# REPLACEMENT SYSTEM VARIANCE REQUEST

# SUBSURFACE WASTEWATER DISPOSAL SYSTEM APPLICATION

Re: Anita Weir Septic System Revision  
Sanford Road  
Augusta, ME

Enclosed is a revised page 3 of the Anita Weir septic system design at 34 Sanford Road in Augusta.

## SUBSURFACE WASTEWATER DISPOSAL PLAN

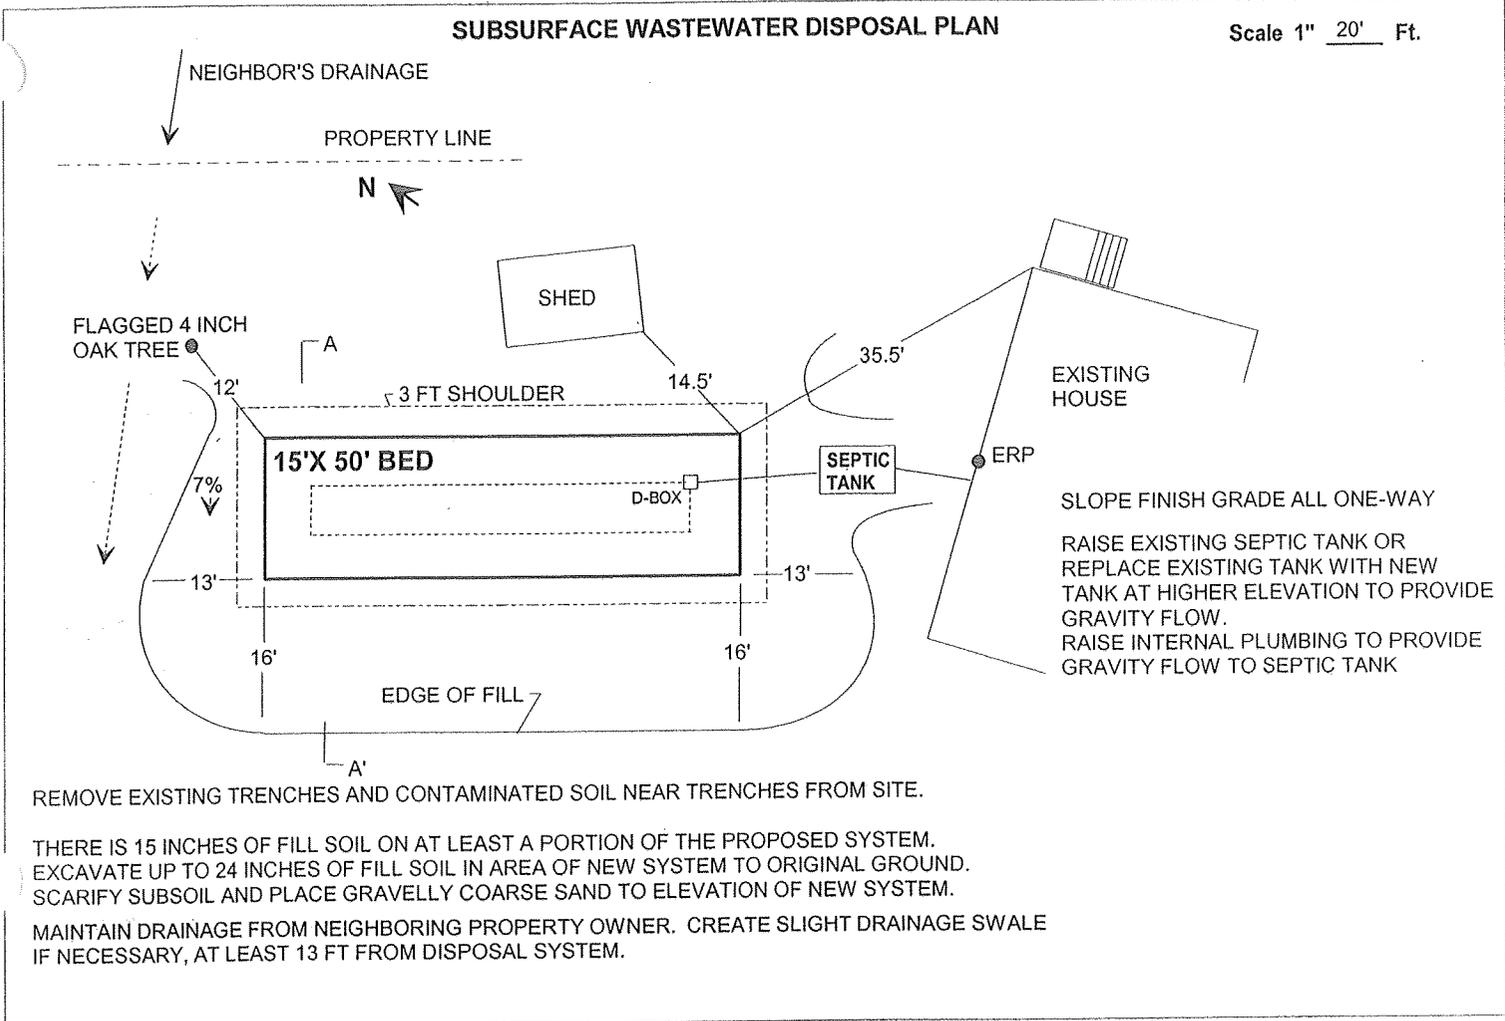
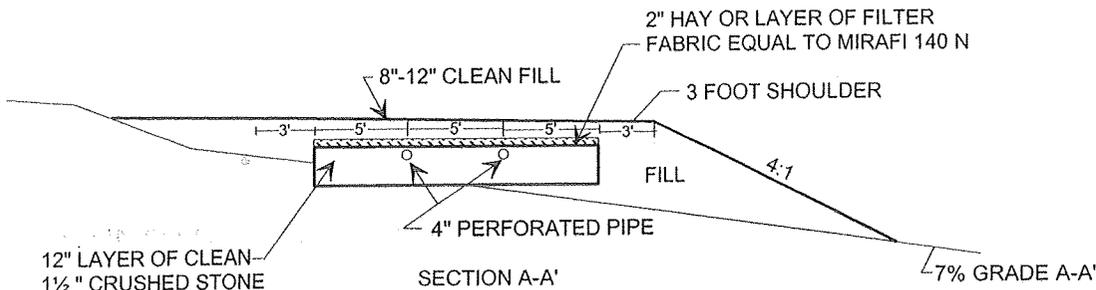
The revised page changes the elevations of the "bottom of disposal area" and "top of distribution pipe". These numbers were revised after reviewing the site with you today.

Finished Grade Elevation **VARIES**  
 Top of Distribution Pipe or Proprietary device **-23"**  
 Bottom of Disposal Area **-34"**
